REVIEW OF THE QUALITY ASSURANCE PROGRAM
FOR THE
DESIGN AND CONSTRUCTION
OF THE
COMANCHE PEAK STEAM ELECTRIC STATION

Prepared
for the
Texas Utilities Generating Company
by
F.B. Lobbin
Consulting Engineer

R-82-01

February 4, 1982

FIGURE 1

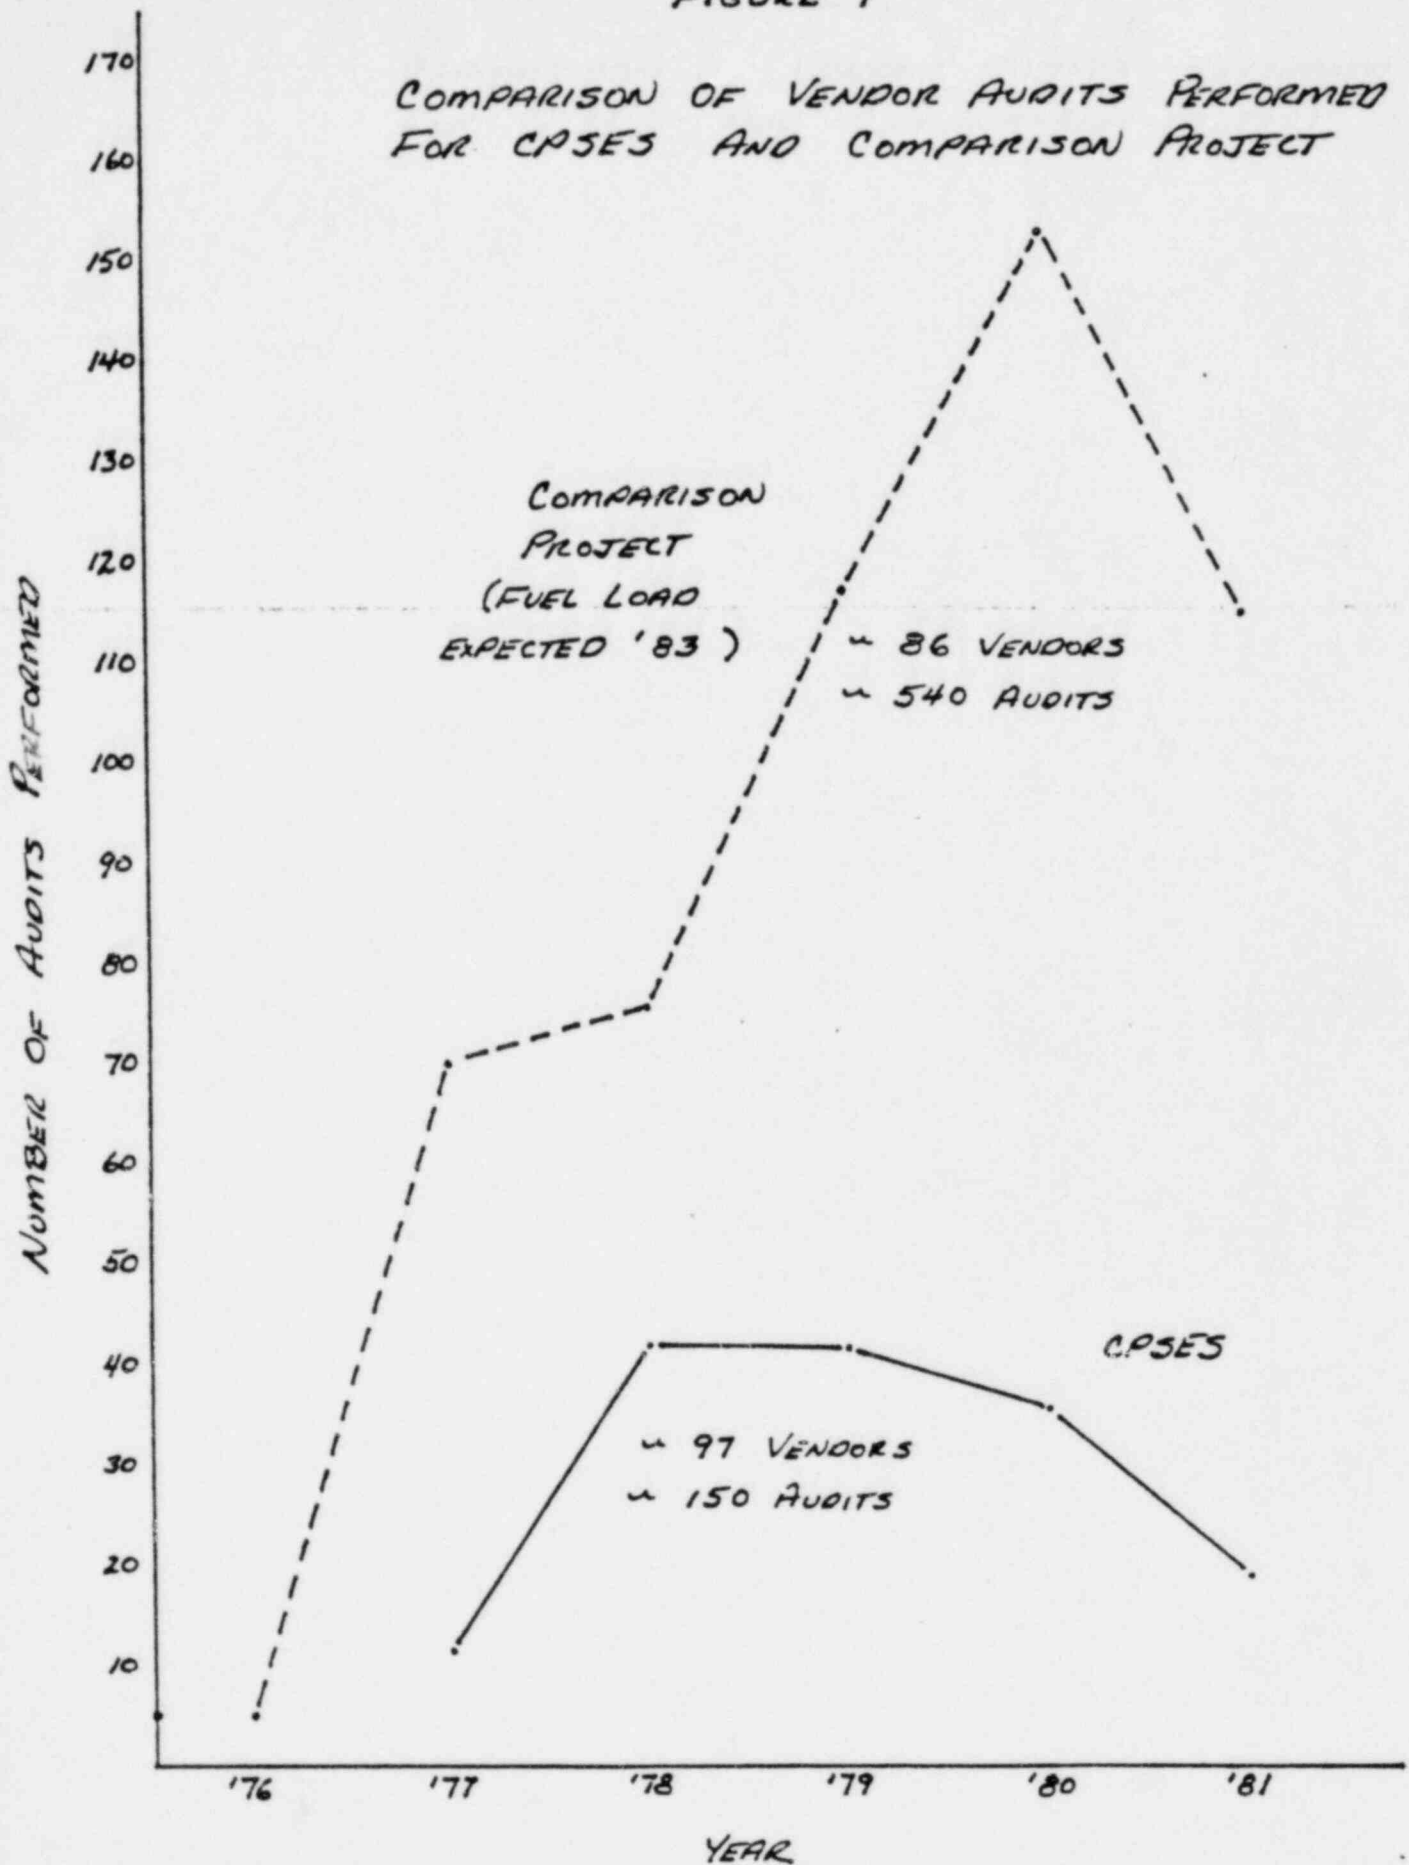
The vendor audit program seems well designed and implemented. What appears at first to be a relatively low level of audit activity compared to other nuclear plant projects familiar to the author (see Figure 1) becomes more reasonable when one examines the close interaction between the vendor audit program and the vendor compliance program which is highly regarded by the author. The combination of vendor preaward surveys, audits, and acceptance inspections seems to be conceived and carried out in a very efficient and effective manner.
